PLANNING UNIT REPORT
DEPARTMENT OF PLANNING AND DEVELOPMENT
May 9, 2006

ZONING MAP AMENDMENT, I.D. 03425 LOCATED IN THE 1100 BLOCK OF ERIN STREET:

1. Requested Action: The applicant wishes to rezone property from R3, One and Two-Family Residential District to PUD(GDP-SIP) Planned Unit Development-Specific Implementation Plan District to demolish six existing residential buildings for the development of a new 2-unit, 14-unit and 16-unit residential buildings in conjunction with seven existing residential buildings, which will result in a 41-unit cohousing development with individual units to be sold as condominiums.
2. Applicable Regulations: Section 28.07(6) provides the framework and guidelines for the Planned Unit Development District. Section 28.12(10) provides the process for zoning map amendments. Section 28.04(22) provides the guidelines and standards for the approval of demolition permits.
3. Report Drafted By: Peter Olson, Planner II.

PROJECT NO. 05-00114
 PROJECT NAME
 APARTMENT CONVERSION
 410 S. Orchard St.
 Madison, WI

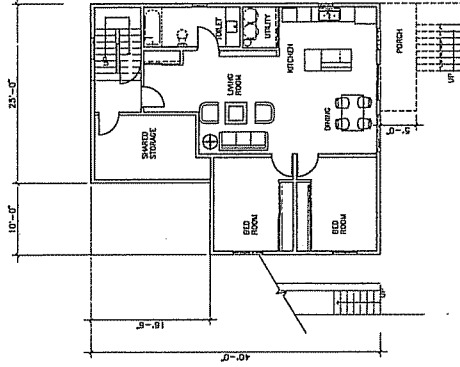
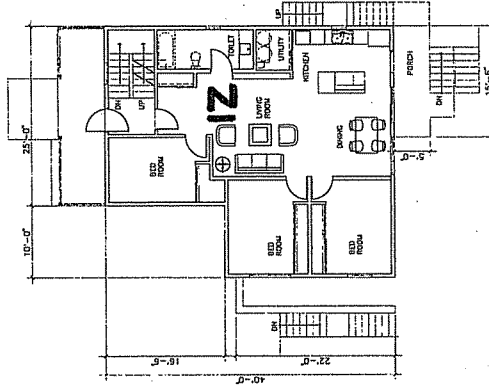
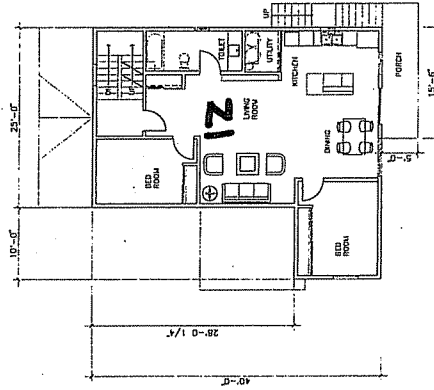
(THIS BUILDING HAS BEEN MODIFIED TO TWO DWELLING UNITS)
